Southern Office Entrance, Ground Floor Plan - Consented Design, December 2006
1:50 @ A3

Southern Office Entrance, Ground Floor Plan - Proposed Scheme
1:100 @A3

8 Shop fronts on West Elevation - Revised Proposals

8.1 Variations to Consented Scheme

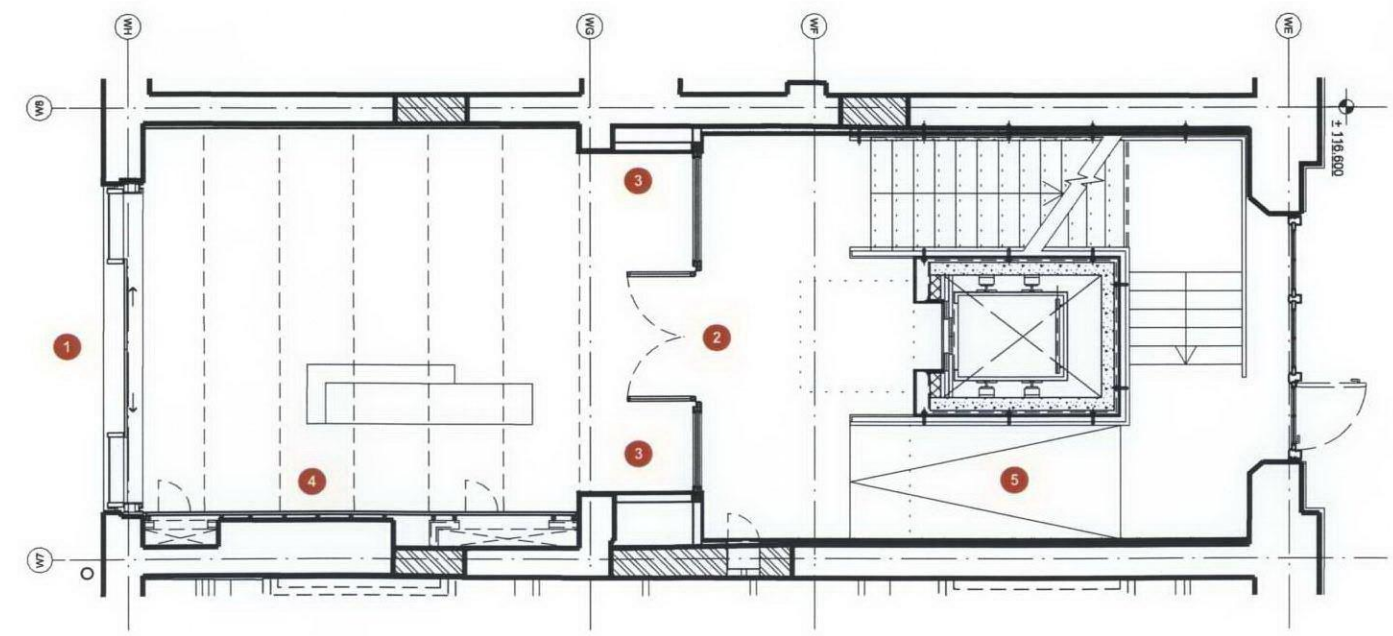
- 1 New glazed screen in consistency with the screen design of the other shop fronts on the western facade.
- 2 Internal glass screen installed at the end of the square opening in order to maximize the floor area of the NR reception.
- 3 Lacquered panelling on walls and ceiling in square opening between the reception and the lobby create a new 'portal' between the two rooms. The panelling conceal horizontal services and a deep down stand beam from the ceiling.
- 4 New lacquered panelling on the southern wall and ceiling in entrance of reception. The panelling conceals vertical and horizontal services.
- 5 The engineered oak floor ramps down in order to accommodate the 200 mm difference in level between the Platform 8 and the new concourse.

6.6 Proposed Amendments of Screen G21/D1a

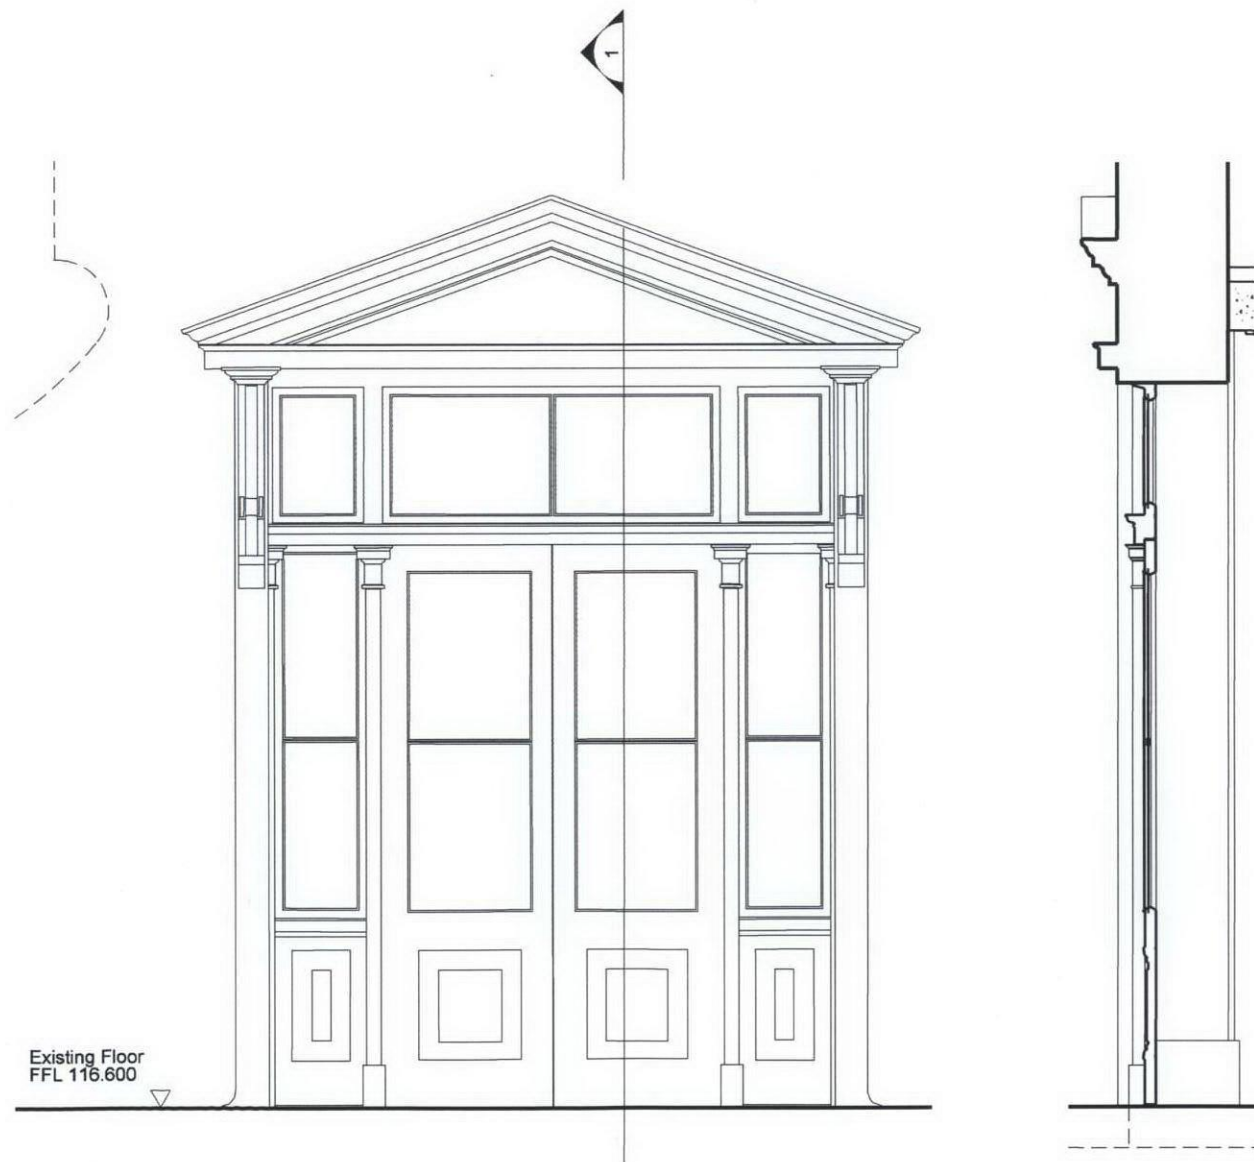
In the original scheme the proposed levels for king's cross station were adapted to match the levels to the existing building. However the proposed levels have been revised to co-ordinate with revised levels in the London Underground Station. After LUL established the existing water levels the levels for the underground station had to be raised by 600mm and consequently the levels for the station had to be raised to maintain the minium distance between the ceiling of the underground and the floor of the overground station. The FFC was raised by 200mm from 116.6 to 116.800.

Options were considered to deal with the interface between the raised floor level of the WCC and the existing levels of the WRB and consented with EH and CBC. These included the option of ramping down within the WCC. This was, however, considered a health and safety risk and therefore not adapted.

To accommodate the raised floor level to the existing, the screen G21/D1a is reduced in size by removing a 200 mm section of the screen from the upper part of the middle glazed section of the screen. By taking out a slice of the middle section, the proportions of the lower part of the screen remain unaltered and a balanced composition is achieved.

The existing stone threshold under the screen is protected and remain in situ. A new threshold of reclaimed york stone, the similar proportions as the existing threshold, is proposed to fit the new concourse level.

WRB Western Elevation - Consented Design, December 2006
 NTS

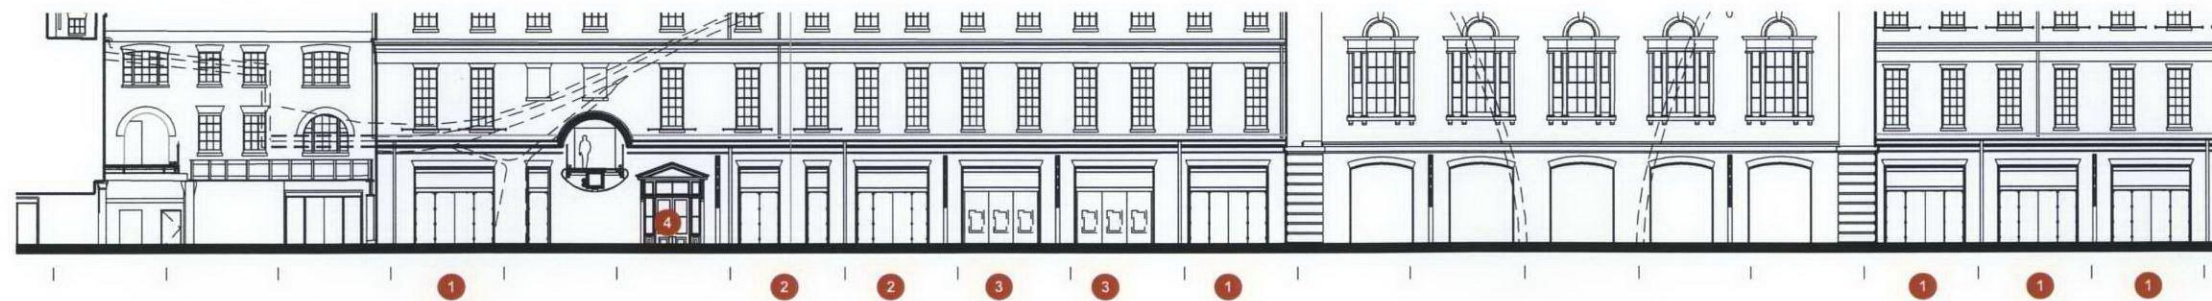
Annotated in red are changes to the current scheme. These variations reflect design development with NR and EH/LBC.

- ① Screen Type 1 - Standard Screen - revised detailing and materials
- ② Screen Type 2 - Atypical screen
- ③ Screen Type 3 - Screen to ATM's & Ticket machines
- ④ Altered screen
